REPORT TO DESIGN COMMISSION City of Sacramento

PUBLIC HEARING
May 19, 2010

Subject: **625 H Street (DR10-033)** Located at the northwest corner of 7th and H Streets, a request to develop an eight story mid-rise 150 unit residential tower including 2,800+/- s.f. ground floor retail and 6,000 s.f. health clinic on 0.55+/- acres in the Central Business District Special Planning District (C-3-SPD) zone.

DR 2

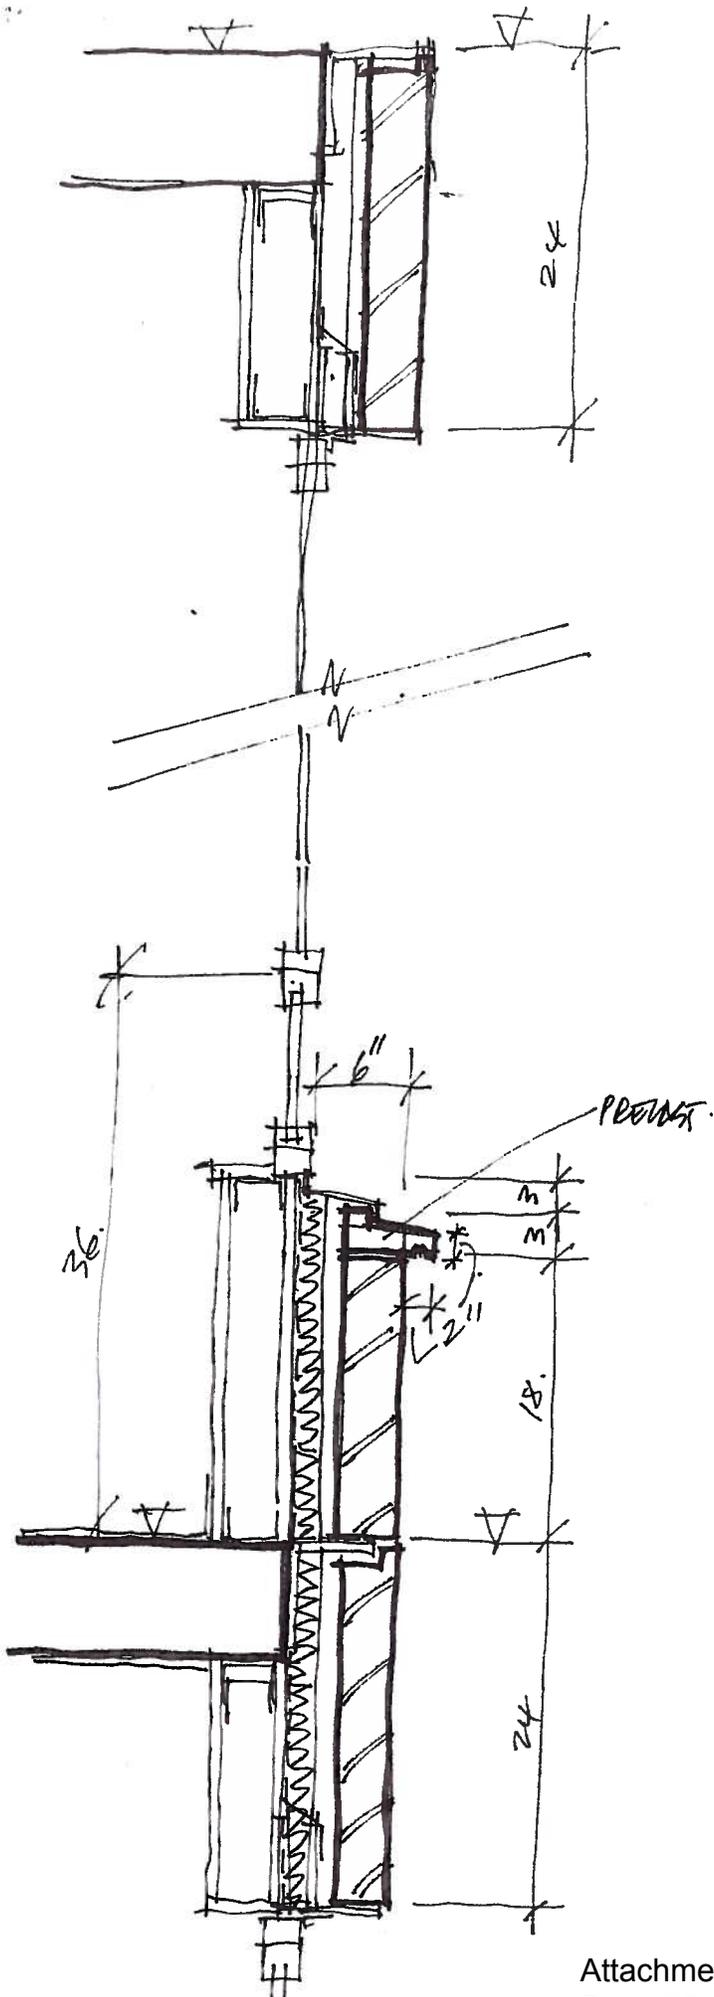
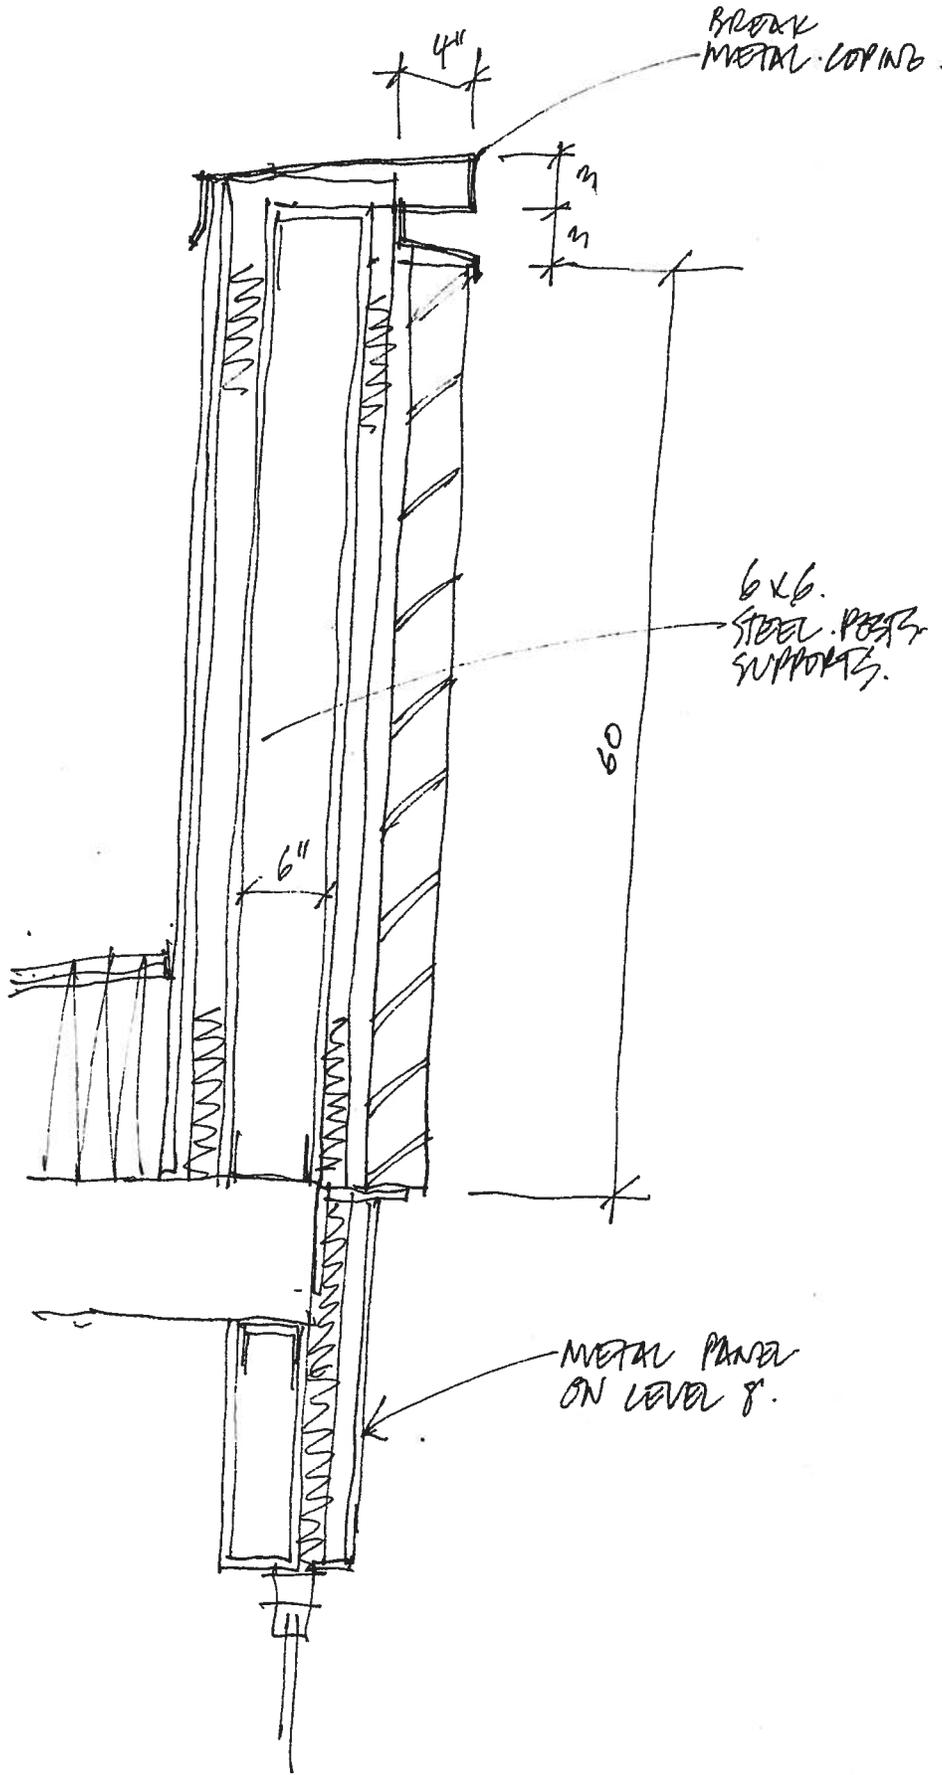
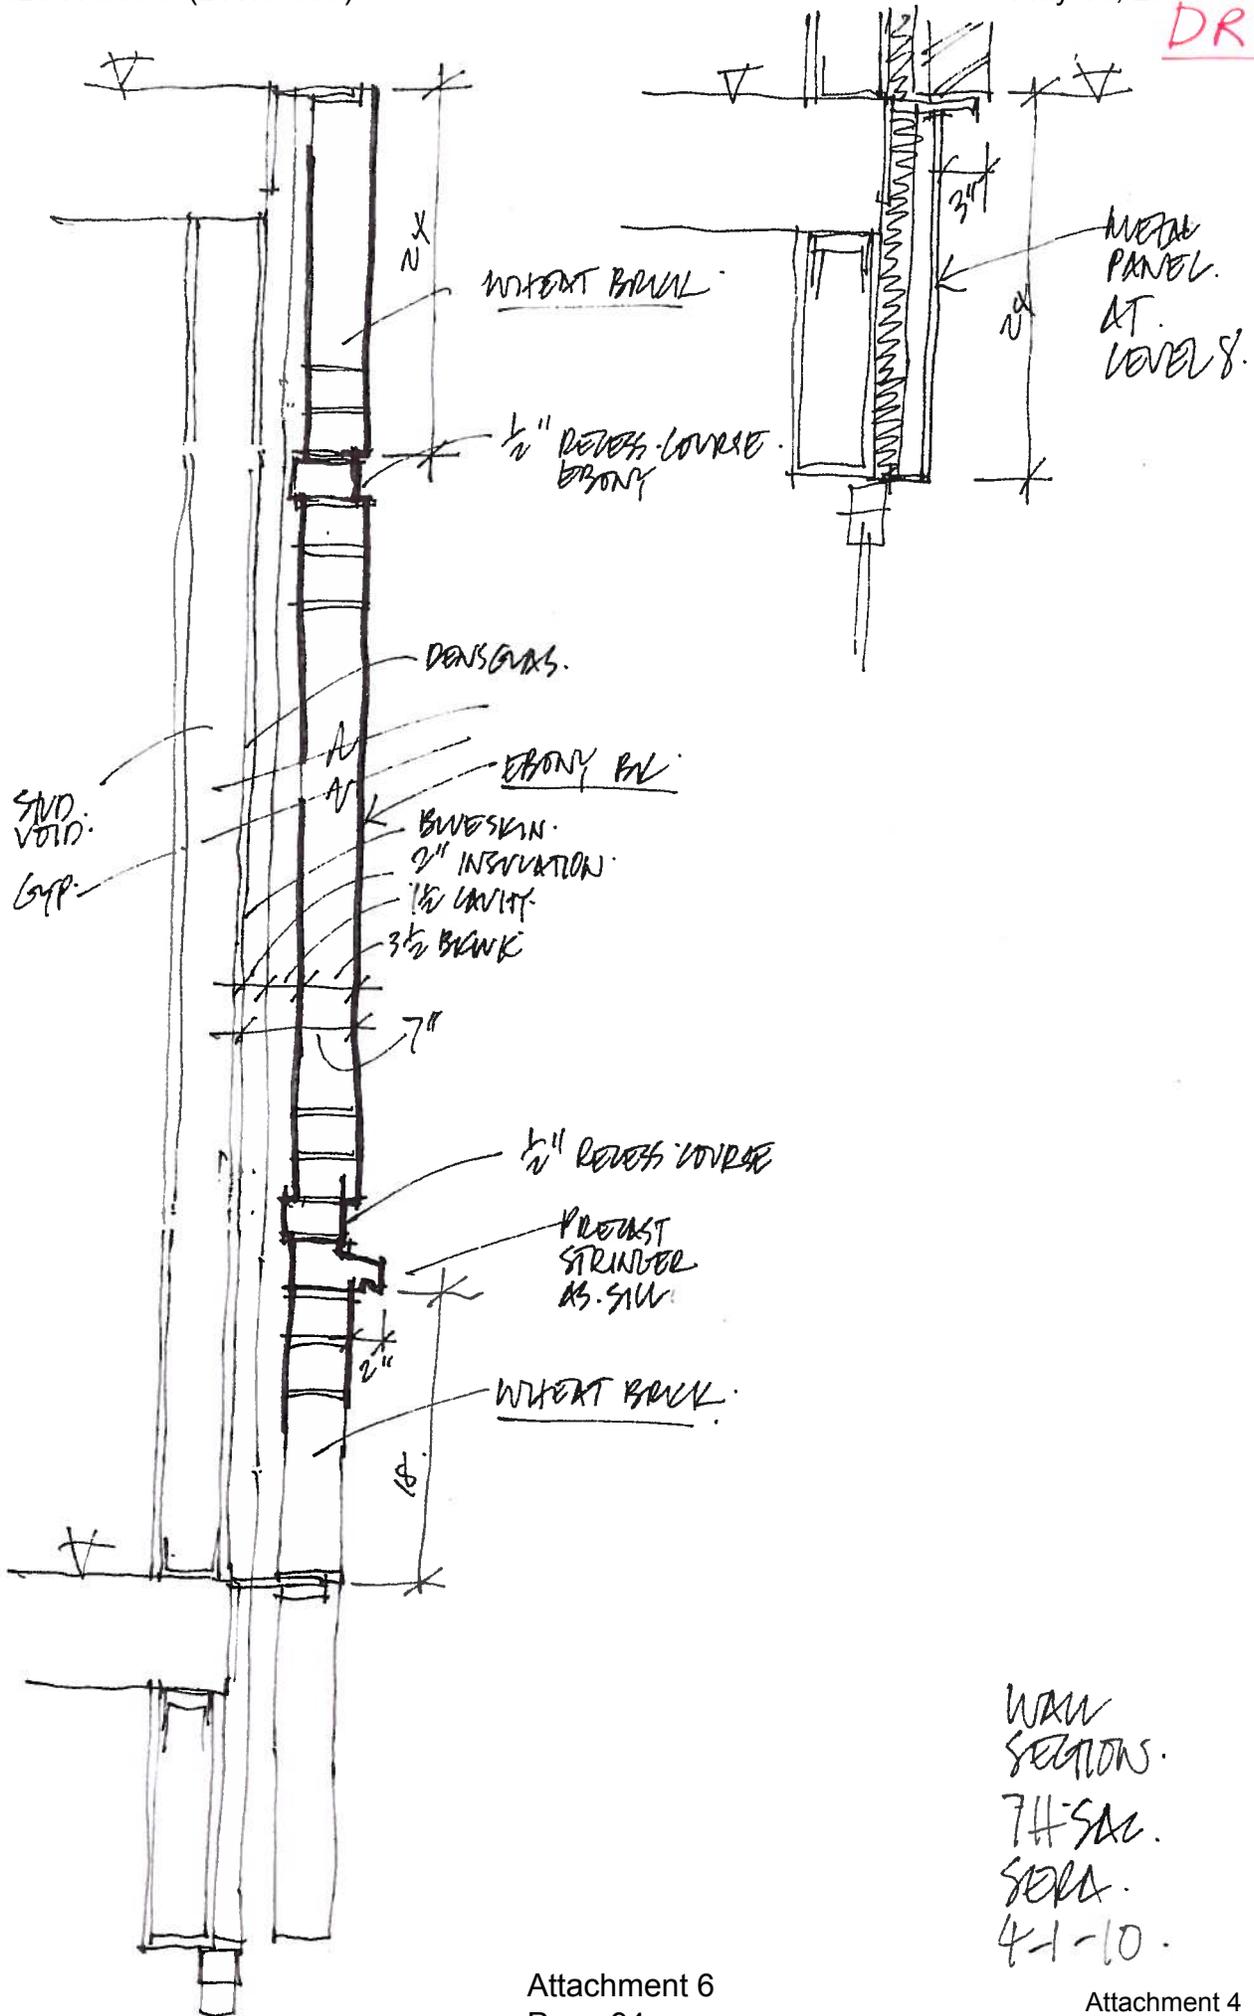
10. Aluminum louvered sunshades have been provided in select locations to assist with the passive solar design of the building. The same level of detail over the other windows has not been provided. The Design Team has provided a sketch DR 2 (Attachment 4, Page 32) that would integrate a course of inset dark brick to simulate the shadow line created by the awning. Staff feels that this inset brick coursing is a step in the right direction, but should be offset to create a similar shadow casting effect as the sunshades. Staff requests the Commission to comment on this item.

DR 3

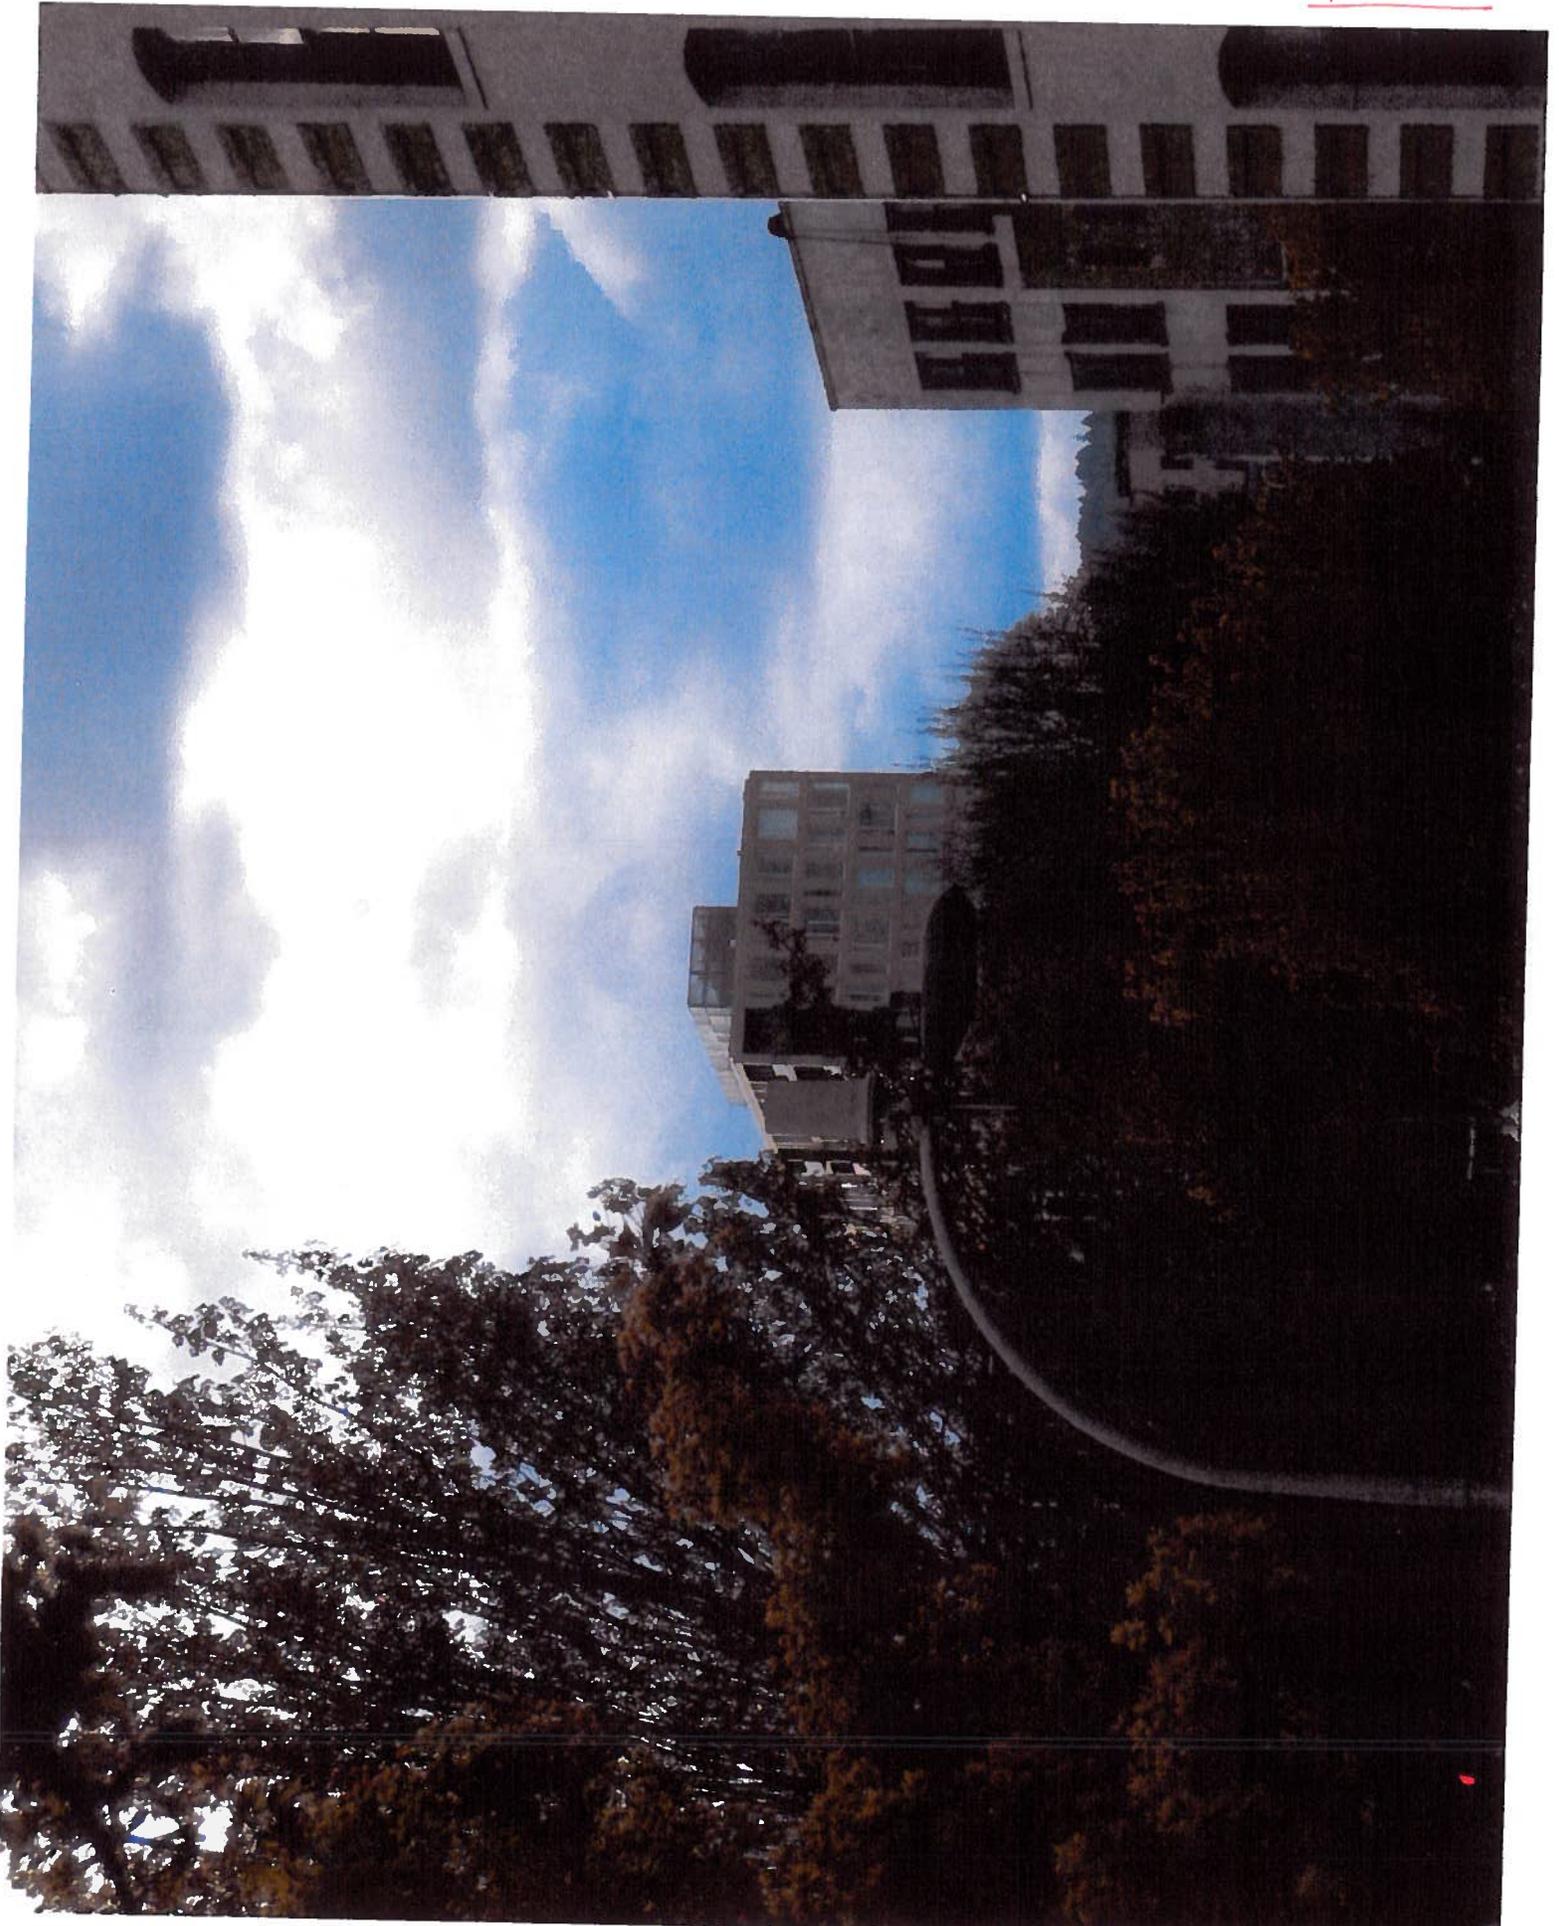
- d. The standpipes will be located in the rear egress stair at the North end of the building.
11. DR Comment: "Provide a night rendering and lighting cut sheets for staff and Commission review."

- a. Preliminary cut sheets from the exterior lighting fixtures have been provided and a night rendering concept has been provided on the cover of the revised drawing packet. See attached Exhibit **DR 4**
